ALERT SERVICE BULLETIN

206-19-136

MODEL AFFECTED: 206A/B and TH-67

SUBJECT: TAIL ROTOR DRIVESHAFT DISC PACK COUPLING NUTS, REPLACEMENT OF

Figure 1 - Typical Tail Rotor Driveshaft Disc Pack Coupling Attachments

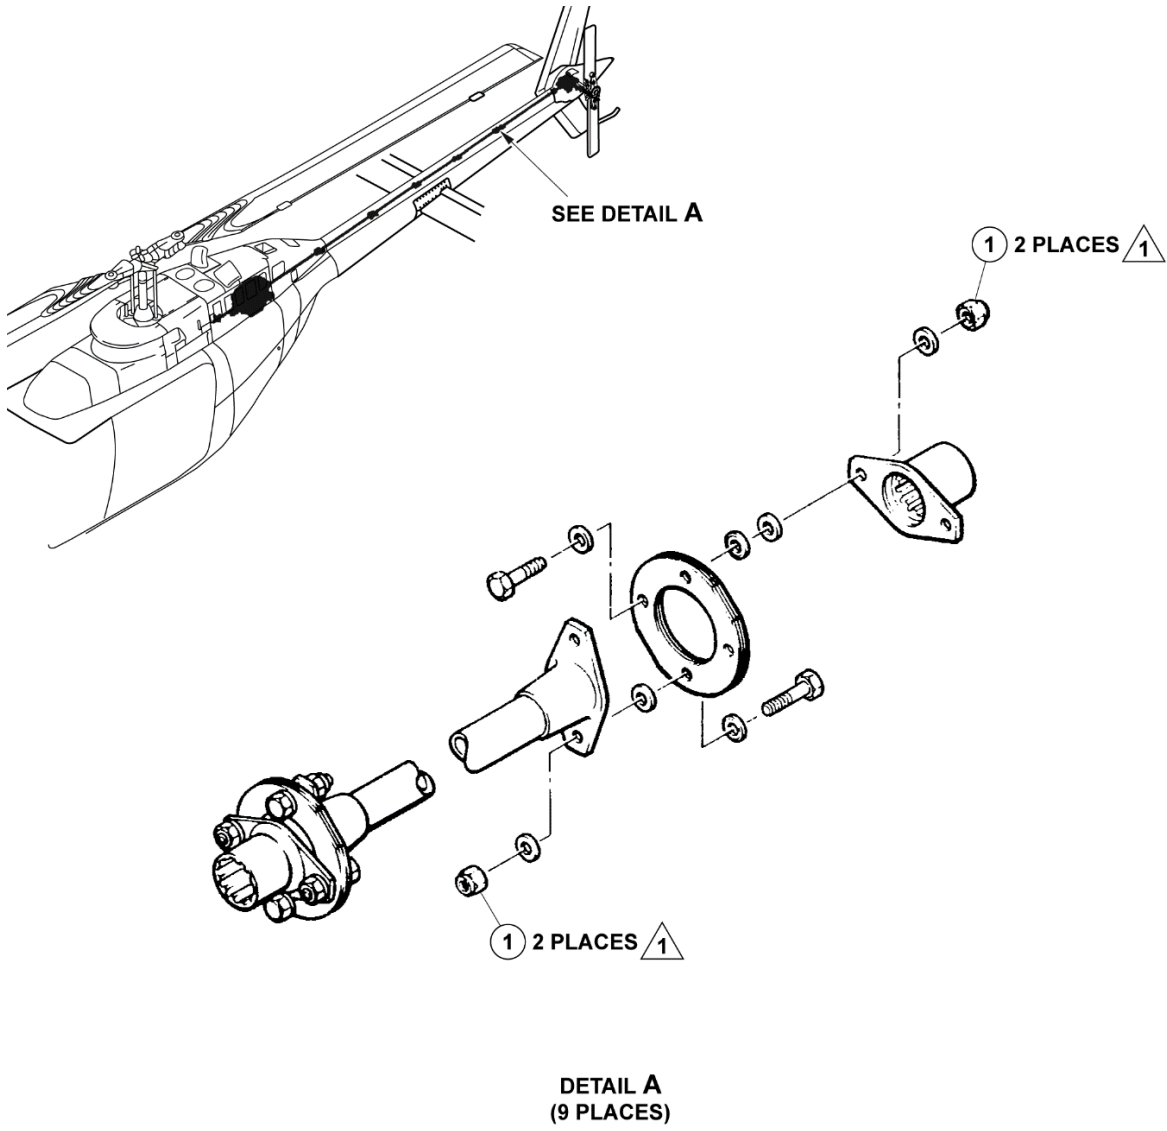
Bell has received reports of cracked or missing MS21042 series nuts. Conditions leading to the cracking or loss of MS21042 nuts may be attributed to improper torque applied, low tare torque, or hydrogen embrittlement. A review of several Service Difficulty Reports has concluded that the events were related to the loss of hardware from tail rotor disc pack (Thomas) couplings.

This Alert Service Bulletin (ASB) mandates the replacement of the MS21042L4 nuts with the 12-point NAS9926-4L corrosion resistant steel nuts.

1. Prepare the helicopter for maintenance.
2. Remove and replace the MS21042L4 nuts at each tail rotor driveshaft disc pack coupling with the 12-point NAS9926-4L nuts (BHT-206A/B-SERIES-MM, Chapter 65). There are four (4) nuts at each disc pack coupling attachment (Figure 1).
3. After torquing of the nuts, apply a torque stripe (witness mark) to each nut using the torque seal lacquer (C-049), or equivalent (Figure 2). Application of the torque seal lacquer (C-049) is used to mark the nuts that have been torqued to visually identify movement of the nuts. Torque seal is brittle and will crack if the fastener moves.

1. Nut (NAS9926-4L) 4 Reqd.

\triangle 1 Required nut quantities: Twenty (20) for the one-piece long tail rotor driveshaft configuration or thirty-six (36) for the segmented tail rotor driveshaft configuration.
